STATE OF MAINE
DEPARTMENT OF TRANSPORTATION
16 STATE HOUSE STATION
AUGUSTA, MAINE 04333-0016

March 21, 2014
Subject: **Augusta Phase 2**
State Project No: 020118.20
Amendment No. 1

Make the following change to the Bid Documents:

SKA-11

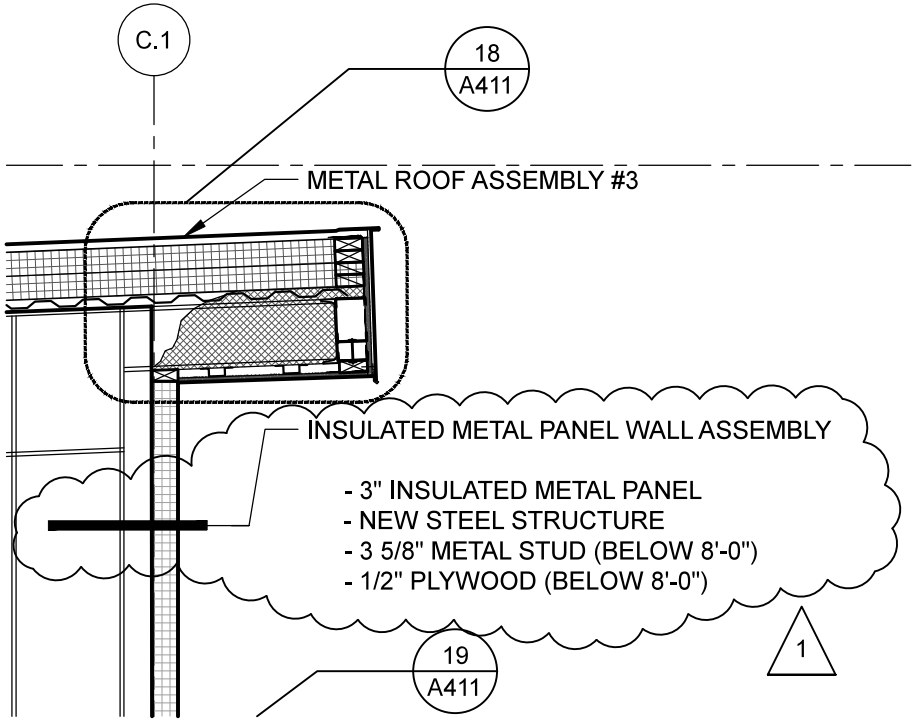
On plan sheet A312 Titled Architectural – Wall Sections, at Section 1 Sign Shop Wall Section **DELETE** top of section ADD in its place top of section per SKA-011 attached

ASSEMBLY CLARIFICATION - SEE 1-A312

SKA-12

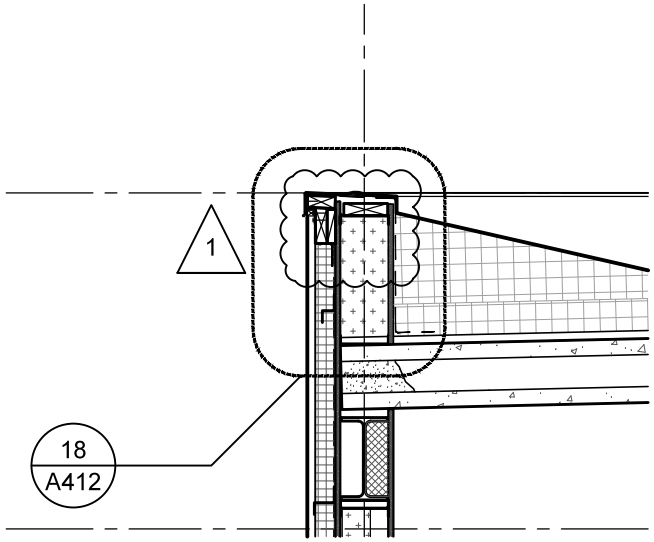
On plan sheet A313 Titled Architectural – Wall Sections at Entry wall section 3 **DELETE** top of section reference to Detail 18/A412 **ADD** in its place top of section 3 reference to Detail 18/A412 per SKA-12 attached

ROOF EDGE MODIFICATION - SEE 3-A313

SKA-13

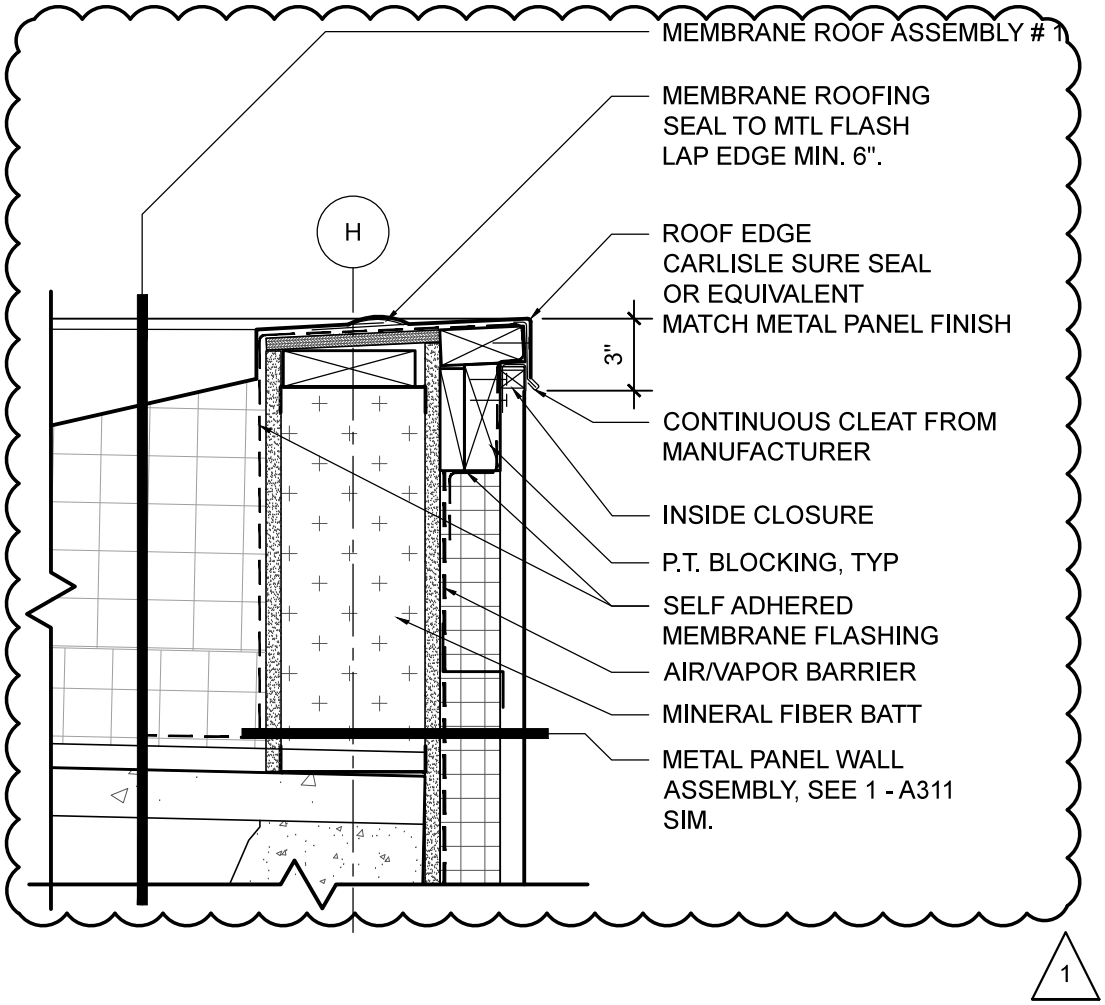
On plan sheet A411 Titled Architectural Section Details **DELETE** Detail Section 2 in its entirety **ADD** in its place Detail Section 2 per SKA-13 attached.

ROOF EDGE MODIFICATION - SEE 2-A411

SKA-14

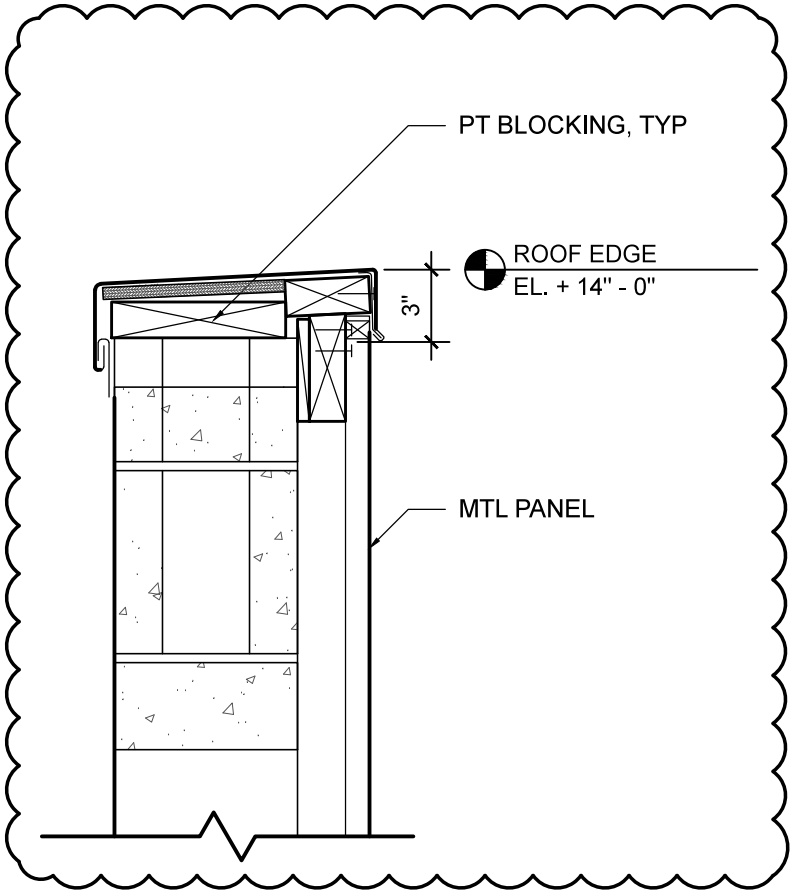
On plan sheet A411 Titled Architectural Section Details **DELETE** Detail Section 10 in its entirety **ADD** in its place Detail Section 10 per SKA-14 attached

ROOF EDGE MODIFICATION - SEE 10-A411

SKA-15

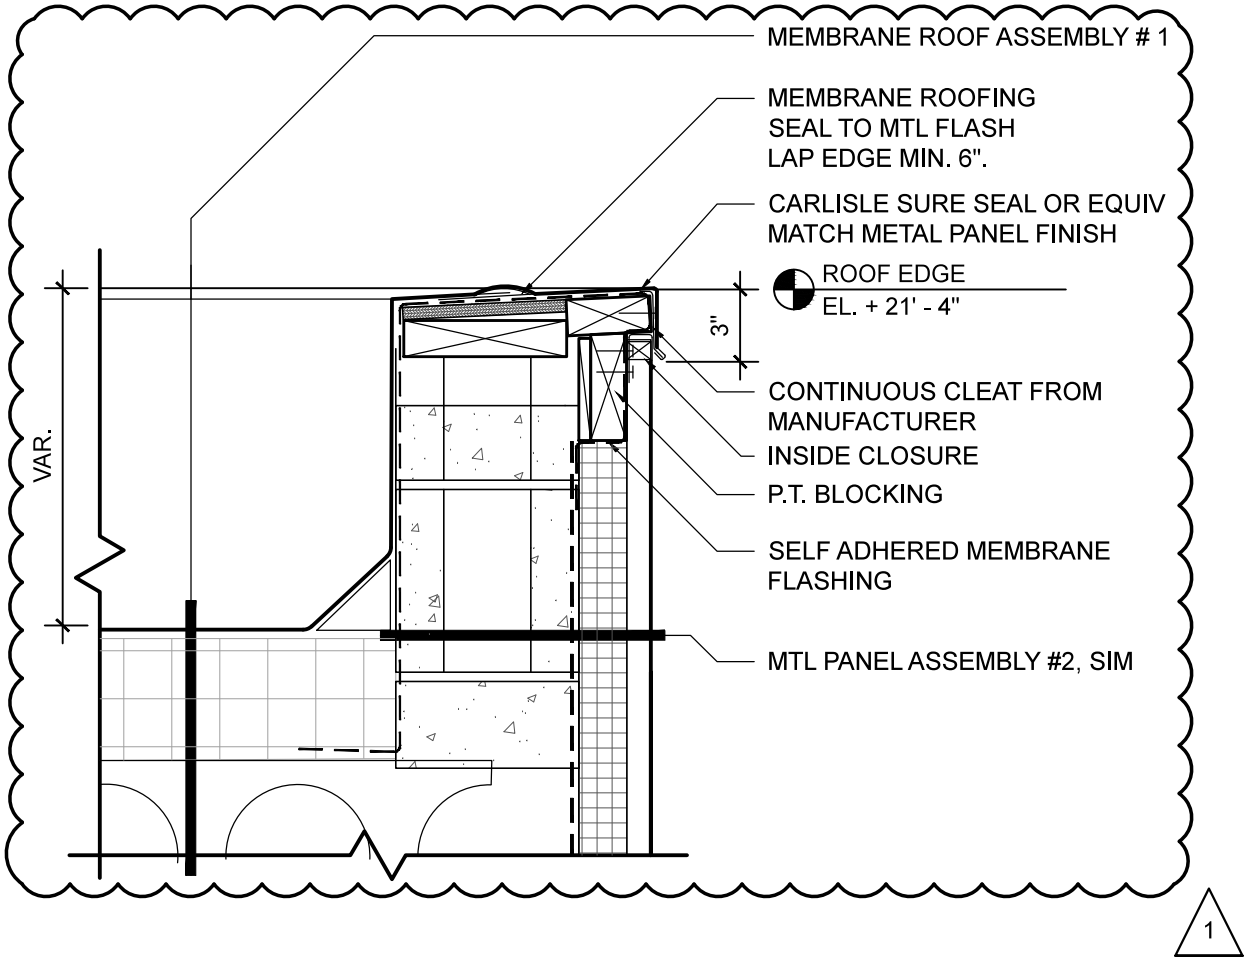
On plan sheet A411 Titled Architectural Section Details **DELETE** Detail Section 11 in its entirety **ADD** in its place Detail Section 11 per SKA-15 attached

ROOF EDGE MODIFICATION - SEE 11-A411

SKA-16

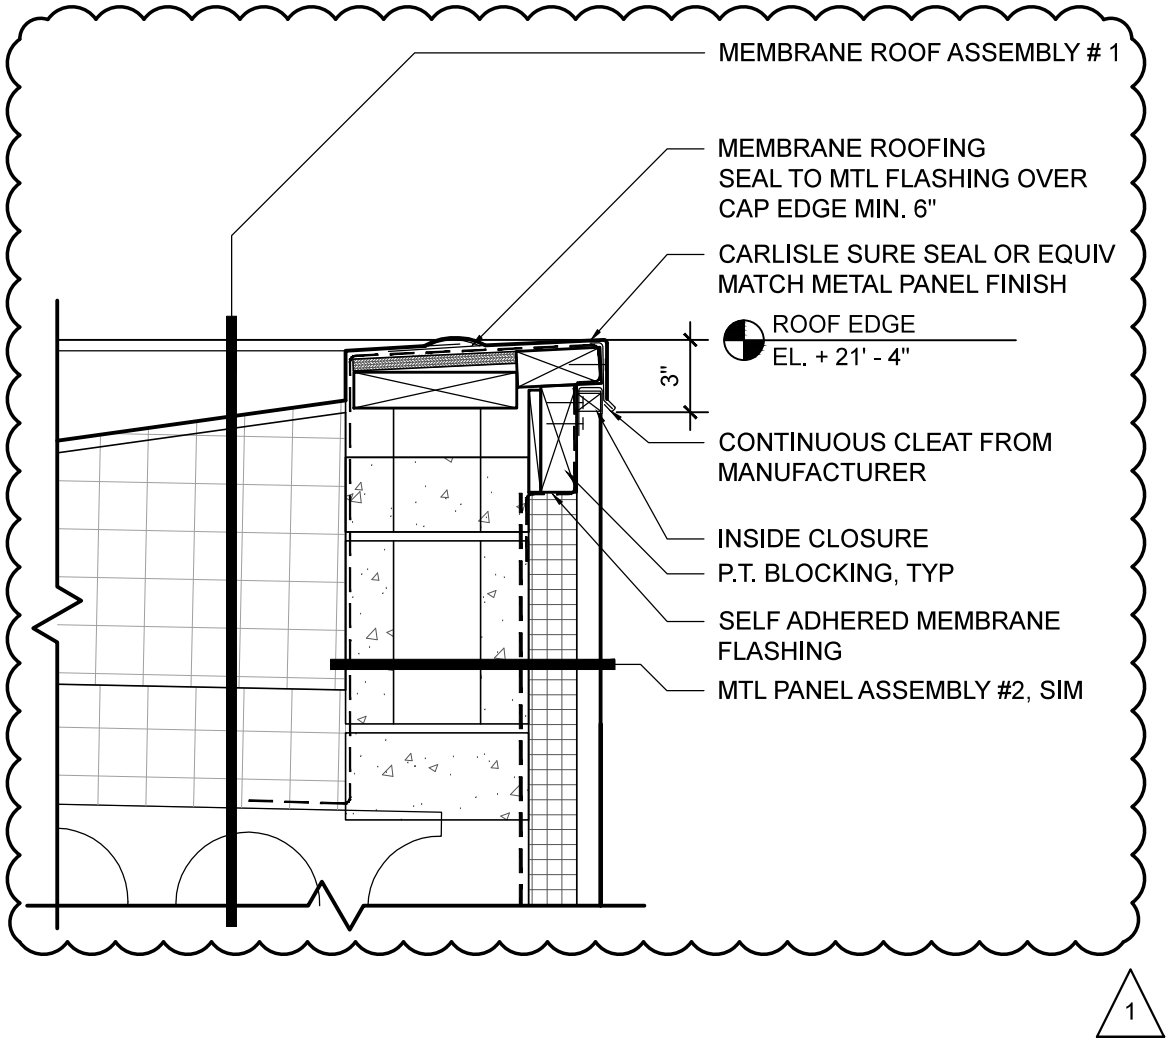
On plan sheet A411 Titled Architectural Section Details **DELETE** Detail Section 14 in its entirety **ADD** in its Place Detail Section 14 per SKA-16 attached

ROOF EDGE MODIFICATION - SEE 14-A411

SKA-17

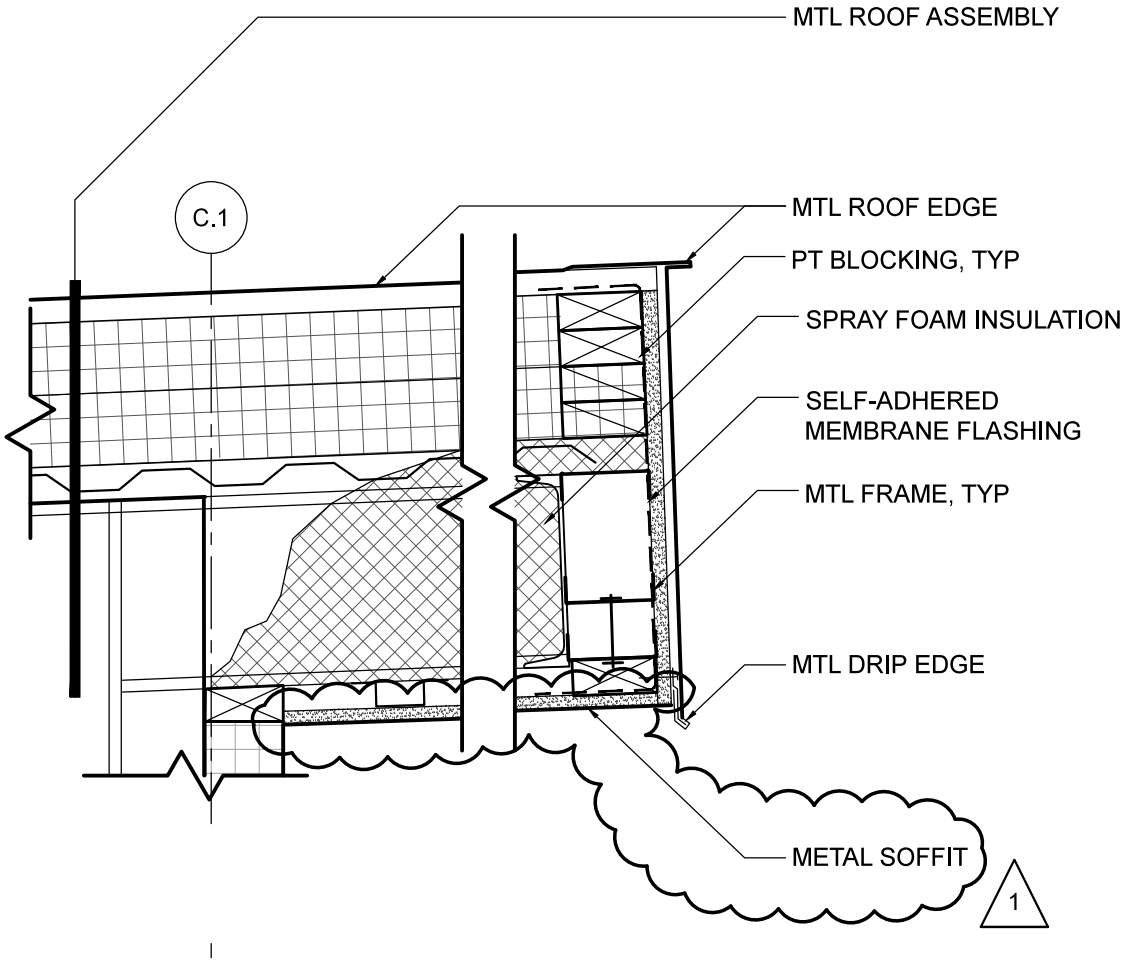
On plan sheet A411 Titled Architectural Section Details **DELETE** Detail Section 18 in its entirety **ADD** in its Place Detail Section 18 per SKA-17 attached

SOFFIT MATERIAL MODIFICATION - SEE 18-A411

SKA-18

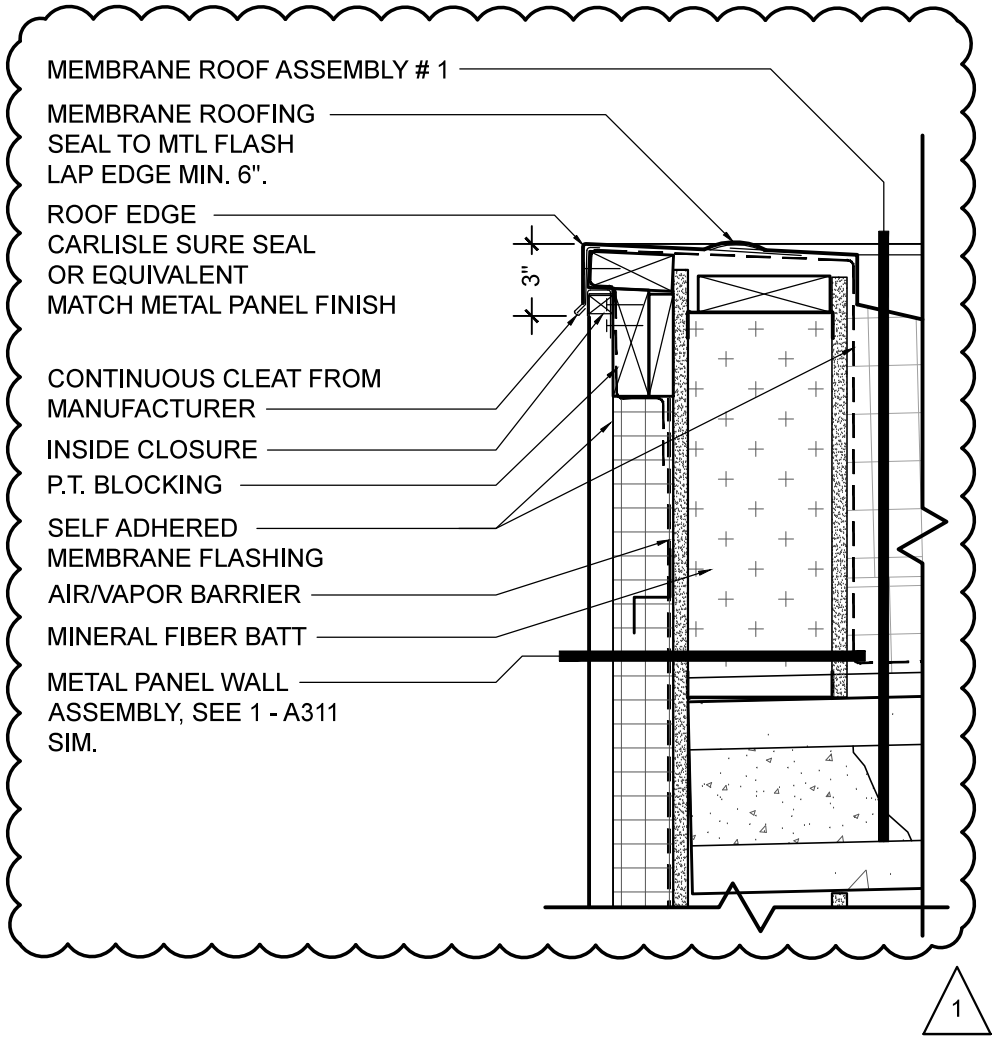
On plan sheet A412 Titled Architectural Section Details **DELETE** Detail Section 18 in its entirety **ADD** in its Place Detail Section 18 per SKA-18 attached

ROOF EDGE MODIFICATION - SEE 18-A412

SKS-01
AMENDMENT #1

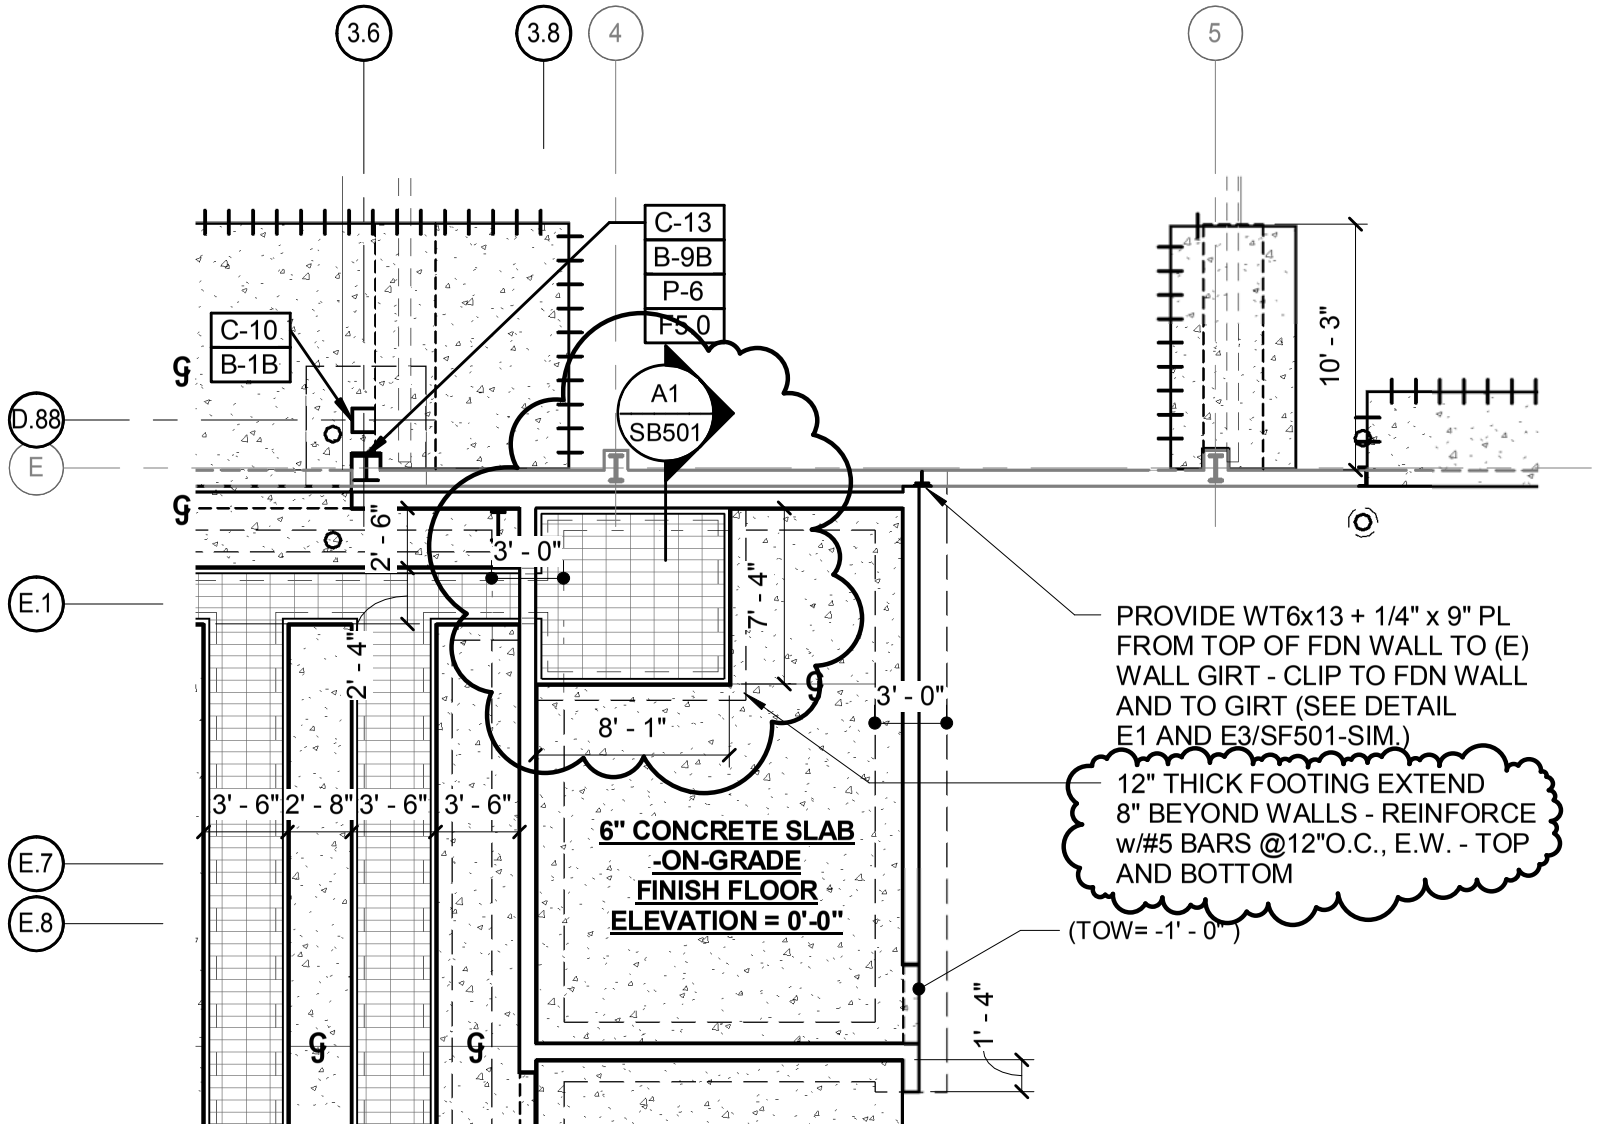
On plan Sheet SB100C Titled “STRUCTURAL - FOUNDATION PLAN – AREA-C”
ADD: CLARIFICATION DETAIL A1/SB501 AT AUGER PIT FOUNDATION WALLS IN MECH-196. AMENDMENT-1 SKETCHES SKS-01 AND SKS-02

SKS-02
AMENDMENT #1

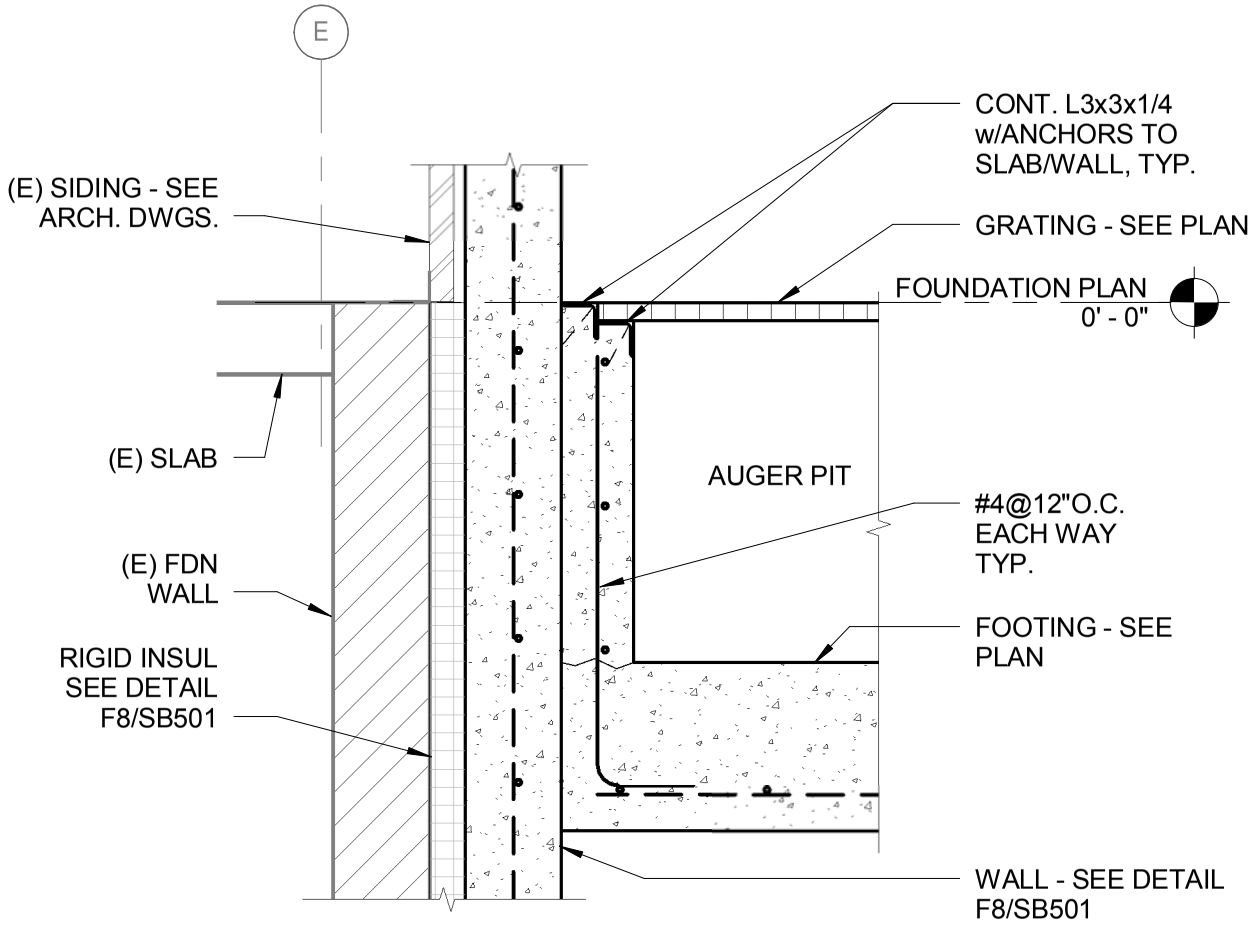
On plan Sheet SB501 Titled “STRUCTURAL – FOUNDATION DETAILS”
ADD: DETAIL A1. AMENDMENT-1 SKETCH SKS-02
